Access Compliance Report

Public Rights-of-Way

Main Street: **ORANGE_AVE** Cross Street: **S_BROOKHURST_ST** Location: **SE**

ADA ID: **RPRK220218195300** Ramp Type: **Type 4 - Parallel** Initial Pass/Fail: **Pass** Overall Compliance: **No** Severity Score: **10**

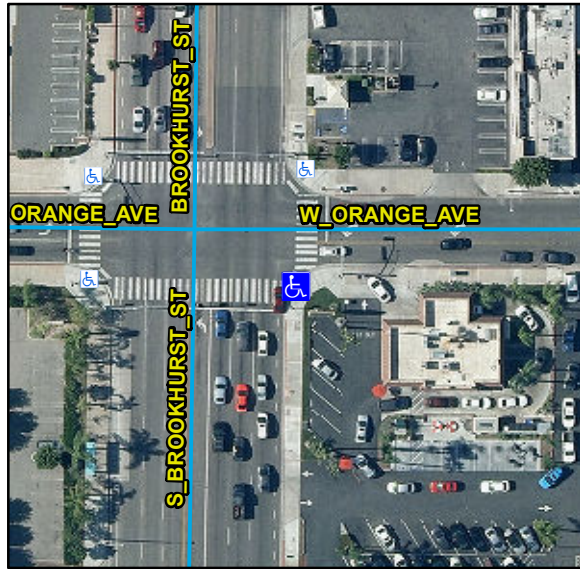
Compliance	Description	Data	Compliance	Description	Data
N/A	Ramp Length LT (in)	105	N/A	Ramp Length RT (in)	84
Yes	Ramp Width LT (in)	108	Yes	Ramp Width RT (in)	108
Yes	Ramp Run Slope LT (%)	5.7	Yes	Ramp Run Slope RT (%)	7.1
Yes	Ramp Cross Slope LT (%)	0.2	Yes	Ramp Cross Slope RT (%)	1.1
N/A	Landing Present	Yes	Yes	DWS Provided	Yes
N/A	Landing Length (in)	105	Yes	DWS Contrast	Yes
Yes	Landing Width (in)	48	Yes	DWS Length (in)	36
Yes	Landing Run Slope (%)	1.4	No	DWS Full Width	No
Yes	Landing Cross Slope (%)	0.6		DWS Offset Type	Single
N/A	Landing Movement Obstructed?	No	No	DWS Offset Left (in)	4
	Landing Movement Type	Curb	No	DWS Offset Right (in)	N/A
N/A	Landing Shared	No			
Yes	Clear Space	Yes			
Yes	Clear Space To Crosswalk (in)	48			
N/A	Marked Crosswalk 1	Yes	N/A	Marked Crosswalk 2	Yes
	Crossing 1 Direction	N		Crossing 2 Direction	W
	Marked Crosswalk 1 Width (in)	144		Marked Crosswalk 2 Width (in)	144
Yes	Ramp Inside Crosswalk 1	Yes	Yes	Ramp Inside Crosswalk 2	Yes

Crossing 1 Slope (%)	0.8		Crossing 2 Slope (%)	2.8
	Crossing 1 Cross Slope (%)	1.7		Crossing 2 Cross Slope (%)	0.2
Yes	Gutter Ponding	No	Yes	Curb Slope	0.5
Yes	Gutter Lip Height (in)	0		Road Run Slope (%)	2.2
No	Gutter Run Slope (%)	12.6		Road Cross Slope (%)	0.5
Yes	Gutter Cross Slope (%)	1.6	Yes	Perpendicular Joint Present	Yes
Yes	Overall Surface Condition	Acceptable			
	Cross Gutter Present?	No		Spandrel Present?	No
	Replace Cross Gutter?	N/A		Replace Spandrel?	N/A

**Remove & Replace Detectable Warning System.
Remove & Replace Gutter.**

R305.1.4, R305.2, R304.5.4, STD 1115
